Product Change Notice

Alps PCN: LO060820_Disti

Title of Change: 2020 Notice of Packaging Change_VR Products

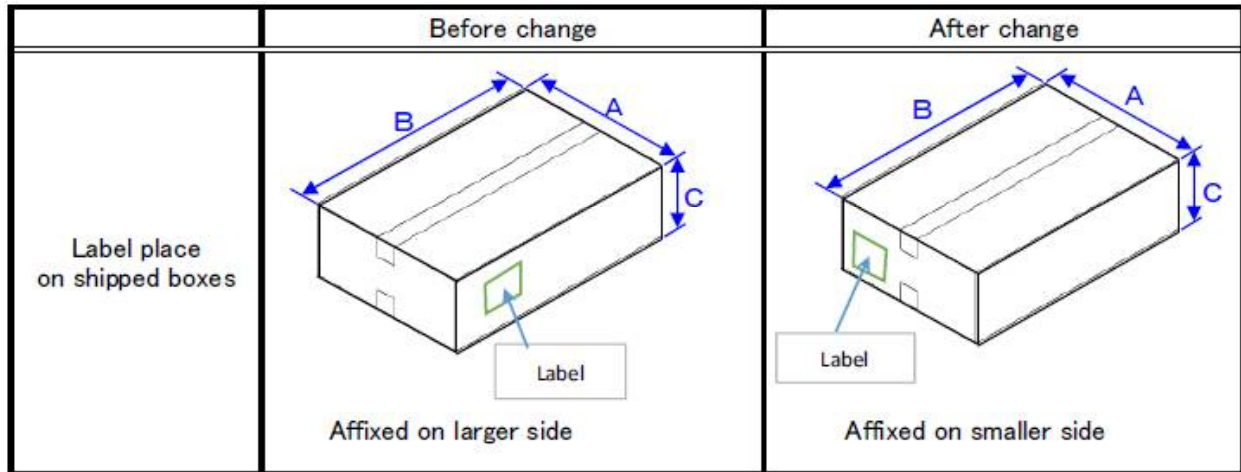
Description of Change: Alps Alpine will be changing the label placement on the shipped boxes of our VR products. This change has no impact to Alps Alpine products. It is only for packaging purposes.

* Quantity of products per box does not change.
